**ORDINANCE NO. 052024B**

AN ORDINANCE OF THE COMMON COUNCIL OF THE CITY OF FISHERS, HAMILTON COUNTY, INDIANA, AMENDING THE TEXT OF THE OF THE FALL CREEK MARKET PUD ORDINANCE, ORIGINALLY ADOPTED ON OCTOBER 2, 2006, AS ORDINANCE NO. 050106A, AS FOLLOWS:

**REQUEST:** Consideration of a text amendment to the Fall Creek Marketplace PUD Ordinance #050106A to allow updates to the concept plan and the land use and development standards, generally located near the intersection of Southeastern Parkway and N. Cyntheanne Road. (TA-24-3)

# Response to Meijer Grocery FSR – TA-24-3 Resubmittal Comments

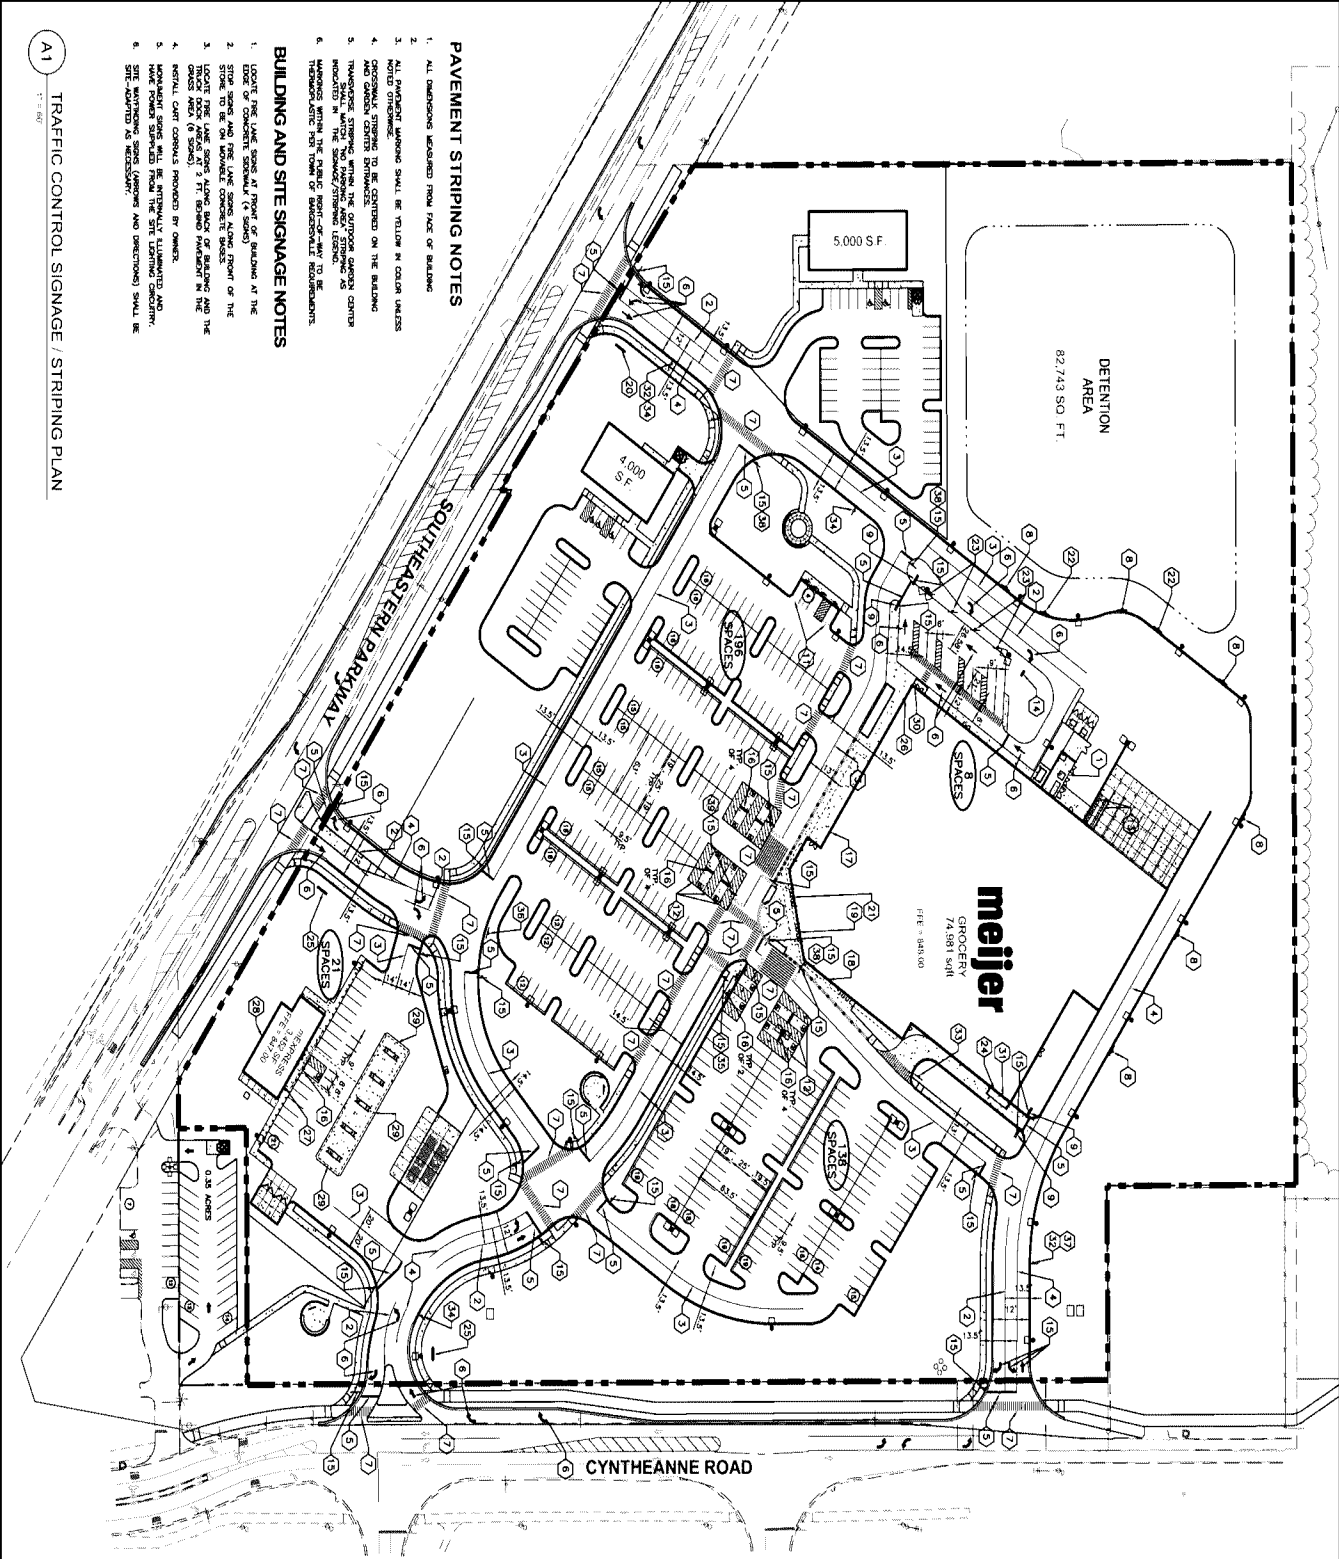
2. **ADA Parking:** Per UDO Sec 6.11.3.A.1, only concrete shall be utilized for ADA-accessible parking spaces and access aisles. Please update plans to comply with this standard.

**Woolpert Response: The site plan has been updated to indicate concrete pavement within ADA parking spaces and access aisles.**

A1 LANDSCAPE PLAN

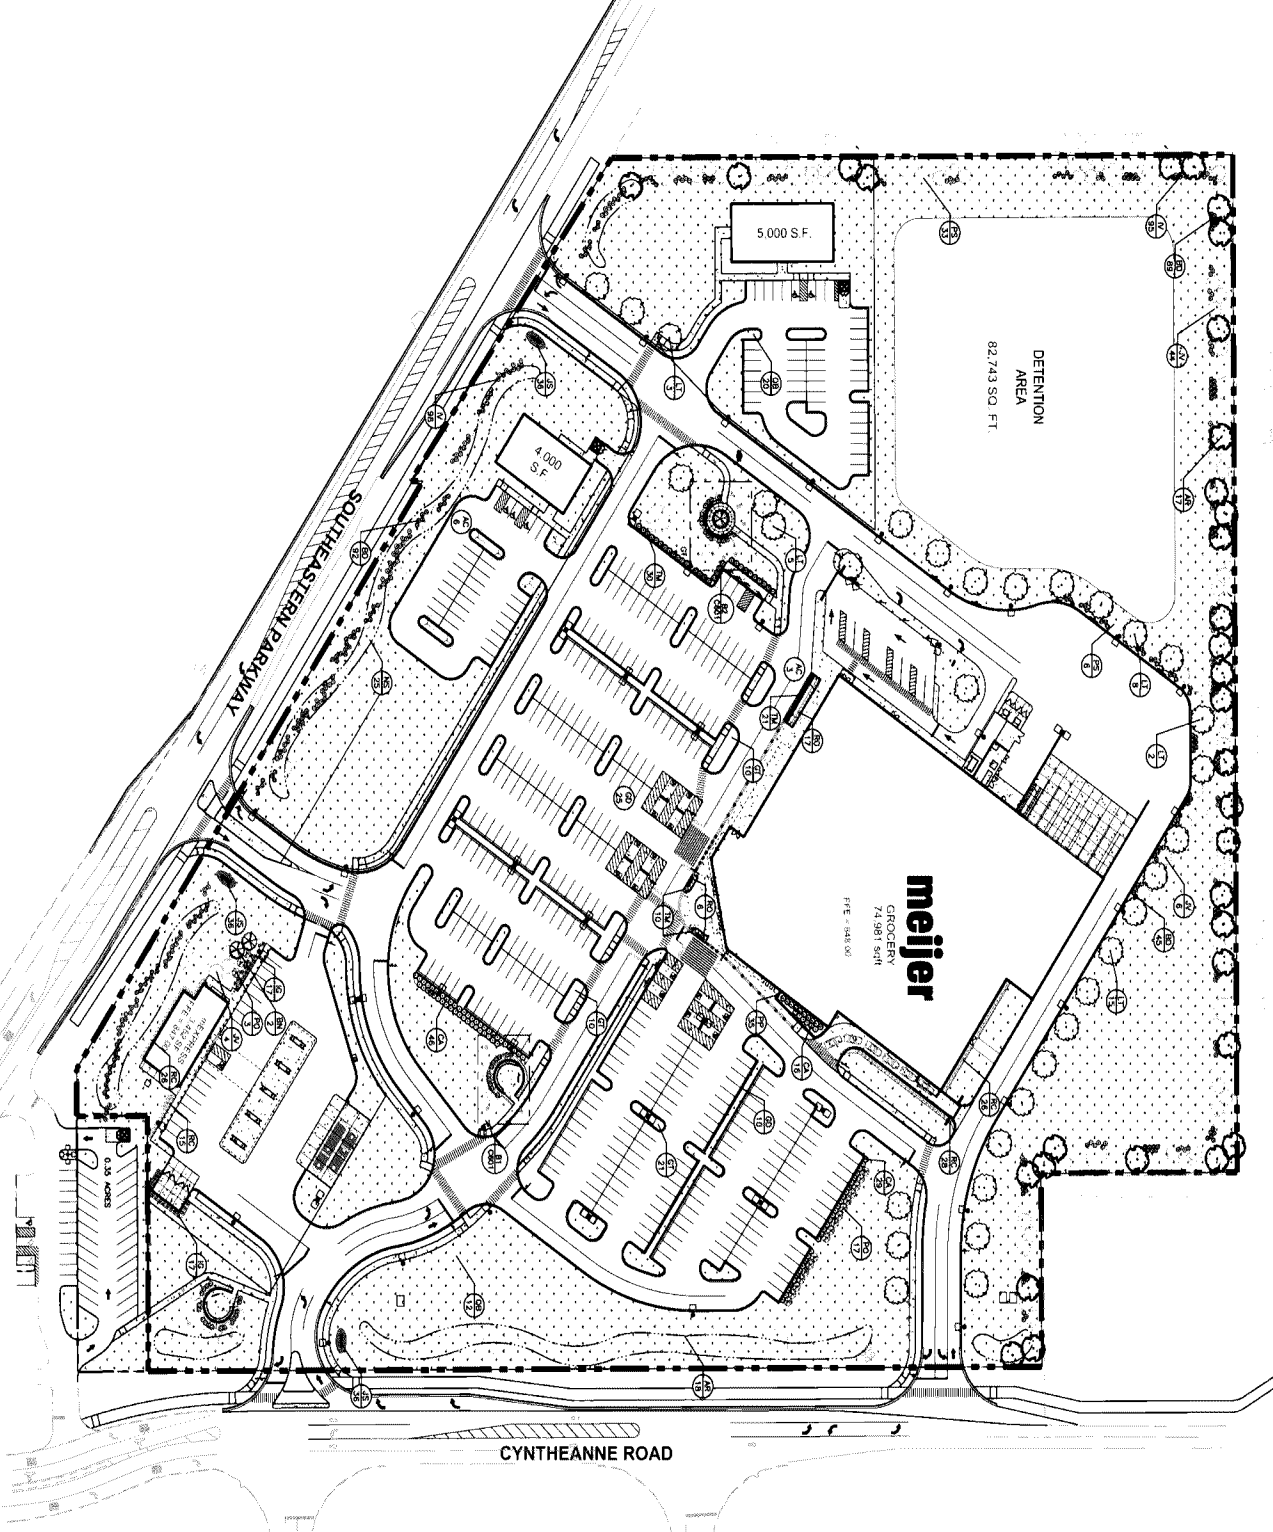
- a. Planting Species: Please ensure all plantings are native and approved species according to the City of Fishers 2021 Planting Guide.
- b. Please see attached landscaping plan showing additional comments.

- a. Proposed tree and shrub species are included on the City of Fishers 2021 Planting Guide in accordance with Article 6.7 of the UDO. Perennial and ornamental grasses that are proposed within Meijer planter areas are supplemental and are not intended to count toward landscaping requirements.
- b. A revised landscape plan is provided as part of this resubmittal package.
